Substantive response of the Local Highway Authority to a planning consultation received under The Development Management Order.

Planning Application Number: 26/00188/REM

Application Address: Land East Of Kennel Lane Witherley Leicestershire

Description of Application: Approval of reserved matters (appearance, landscaping, layout and scale) of outline planning permission 22/01190/OUT for residential development of up to 50 residential dwellings

The LHA have reviewed drawing 2393-03 Revision F (Proposed Site Layout) and note the following points to be addressed in order for parking to be in accordance with the LHDG.

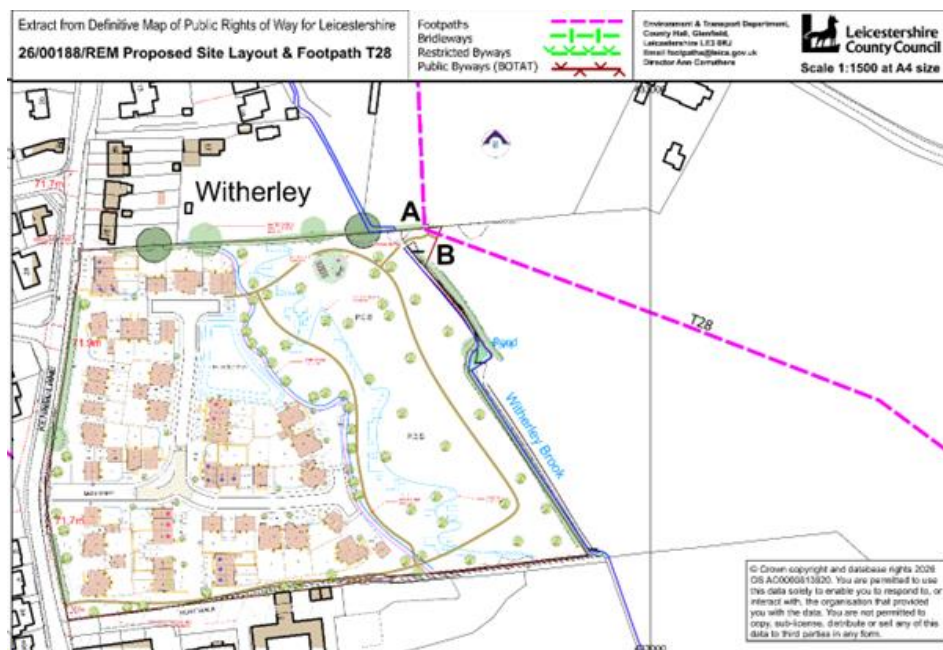
- Parking measurements should align with [Figure 44](#) of the LHDG. Spaces are required to be a minimum size of 2.4m x 5.5m, with an additional 0.5m if bounded by a wall, fence, hedge, line of trees or other similar obstructions on 1 side, 1m if bounded on both sides. Parking for plots 2, 4, 5, 8, 9, 10, 11, 12, 17, 25, 26, 27, 28, 29, 30, 31, 34, 35, 36, 37 and 45 should therefore be amended.
- In order for garages to be counted toward parking provision they must have the minimum dimensions outlined within the [LHDG](#). The garages for plots 1 and 18 should therefore be amended.
- As per [Table 28](#) of the LHDG, dwellings with up to three bedrooms are required to have two parking spaces, parking for plots 25, 26, 36 and 37 should therefore be amended.

Although the parking is not in full accordance with the LHDG, with some spaces being 5m in length and some spaces not allowing for extra width when bound to the side, alongside a shortfall on 4 parking spaces, should the site remain in private ownership, this would be acceptable as it would not be expected to be contrary to paragraph 116 of the NPPF (2024). However, parking will be required to be provided to LHDG standards should the applicant wish to put the site forward for adoption.
